File RZP-1996-179

Name: Canyon View - Phase 4 - South Camp Road and Canyon View Drive

Re-zone, Revised Preliminary Plan & Final Phase IV

FILE: RZP-96-179
DATE: August 28, 1996
STAFF: Bill Nebeker
REQUEST: Final Plat for Canyon View Phase 4, Revised Preliminary for Phases 4, 5 & 6, Rezone from RSF-4 to PR-2 for Phases 5 & 6
LOCATION: West of Wingate Elementary School at 334 South Camp Road.
APPLICANT: Jim Thomas for Thomas & Sun

**CANYON VIEW
SUBDIVISION
REVISED PRELIMINARY**

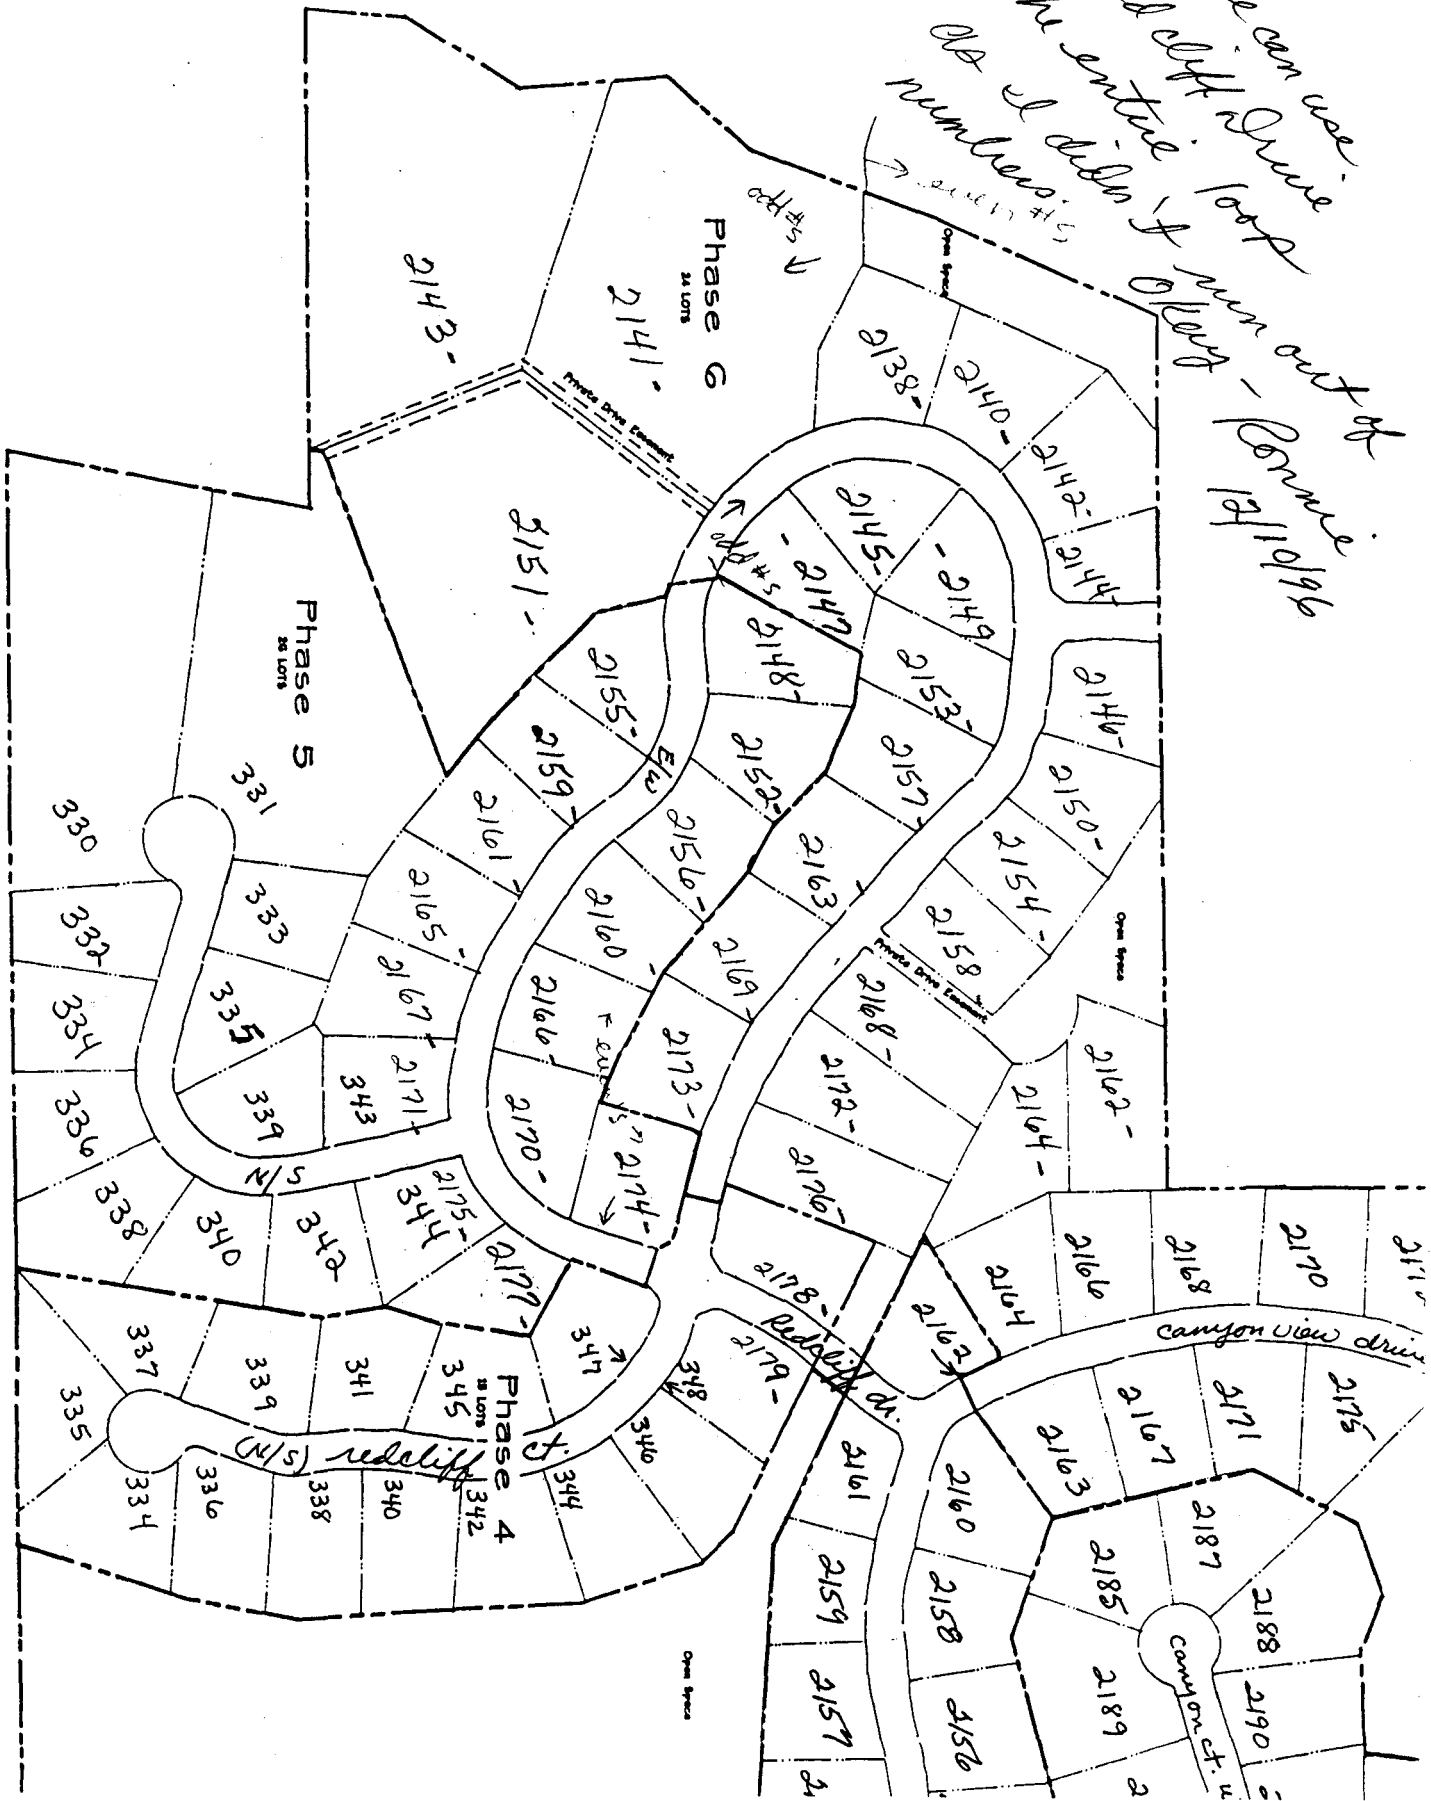
2. Please clarify the use and ownership of the small parcel directly south of lot 1, block 3 (Phase III). (See note #3 above.)
3. Does the private drive easement over the three large lots in Phase 6 access other lots outside this subdivision?
4. What is intent of open space in the far western corner of this site?

1. Submit a revised preliminary plan showing the new location of Tract B irrigation pond unless the plat and construction plans are revised, moving the pond.
2. The private drive easement over the large lots in Phase 6 must be extended to the property line for each existing private road.

1. Redlands Water & Power would like to reduce the number of road crossings for their canal to one if possible. We had hoped that by using a shared private drive, the crossing could be minimized. Redlands Water & Power has also been reluctant to move the irrigation ditch. This limits the configuration of lots in this area, as well as the number of lots. The developer hoped the proposed configuration would be allowed to minimize the impact on Redlands Water & Power while still allowing developable lots.
2. This parcel will be added to lot 1 block 2, Phase IV.
3. yes, two lots with existing access at the corner property pin where the easement leads.
4. Possible detention area, unstable area we don't trust people with, an anomaly.

COMPOSITE PLAN

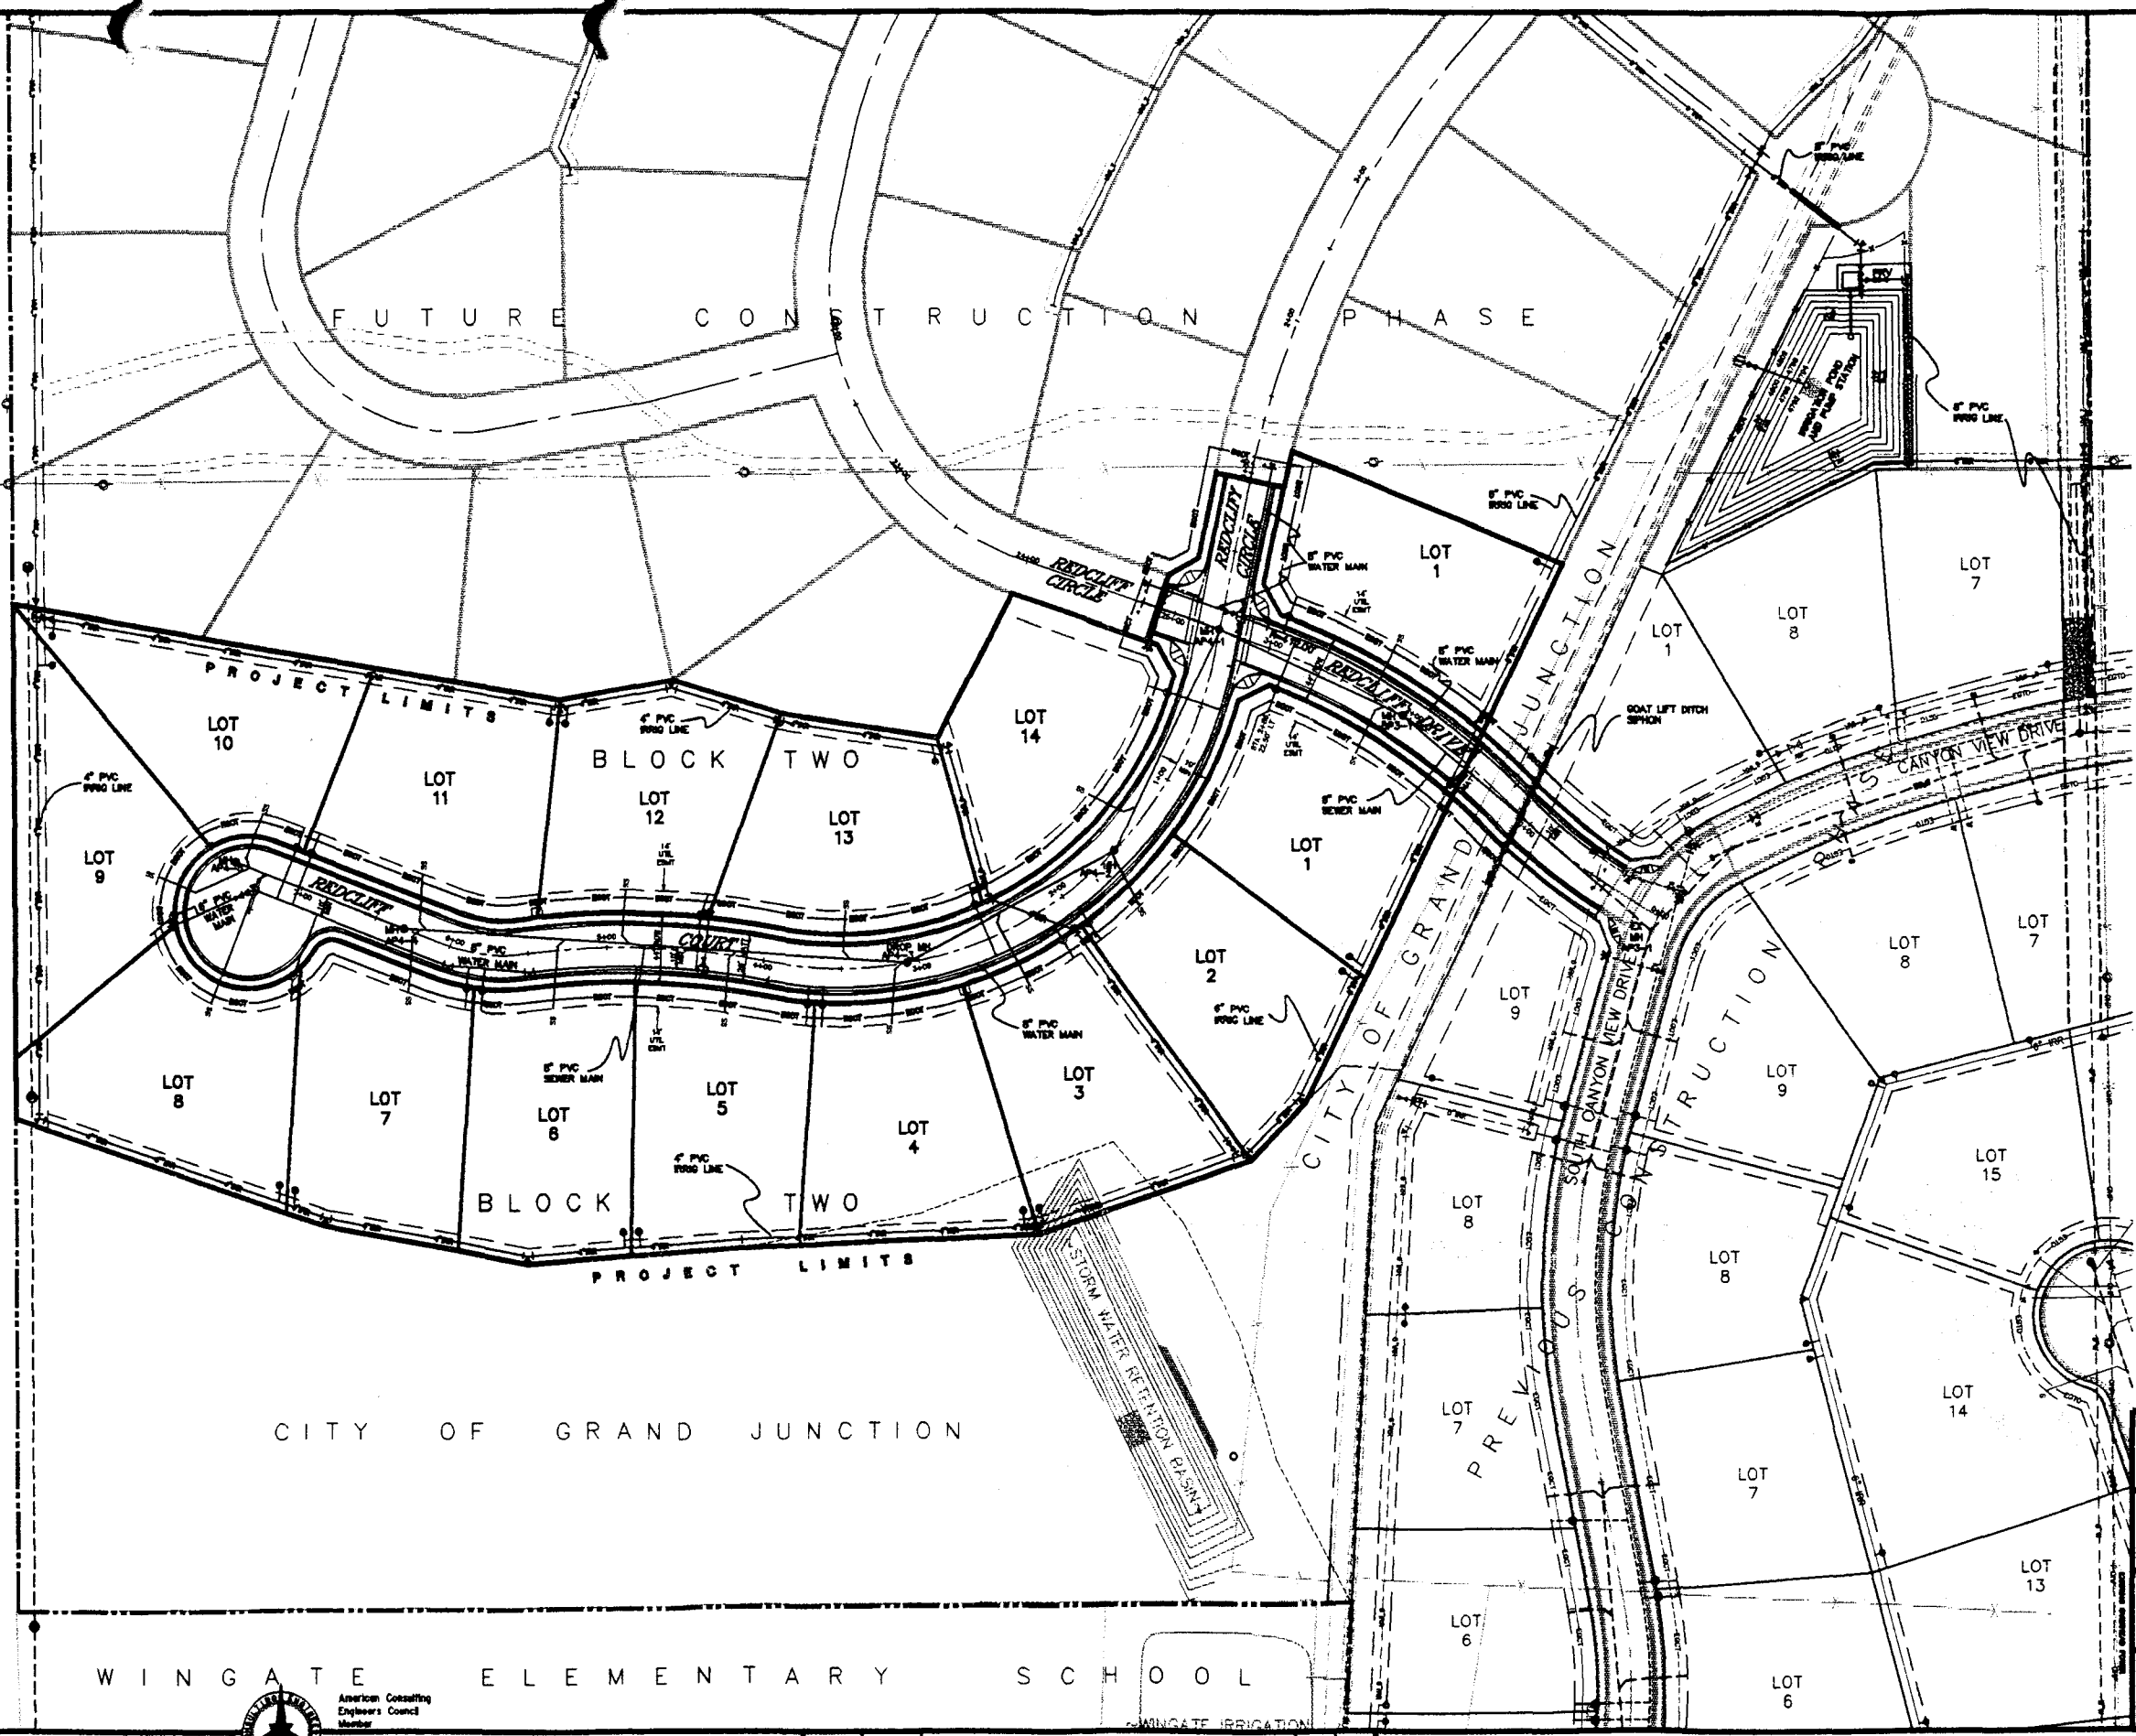
2. Preliminary plan for Phase V and VI:
 - a. Inadequate information submitted to evaluate in regards to utilities.
3. North arrow on composite plan 90 degrees off.

1. Noted
2. The Community Development Department indicated that what we submitted would be adequate. We are revising a preliminary plan which was submitted in 1993.
3. North arrow has been corrected.
4. Sewer Trunk Fees should have been covered by the Goat Wash Extension already paid for in Phase I. Acreage fees will be paid at recording of final plat for Phase IV.
5. Sewer stub will be shown.
6. Notes will be shown where appropriate.
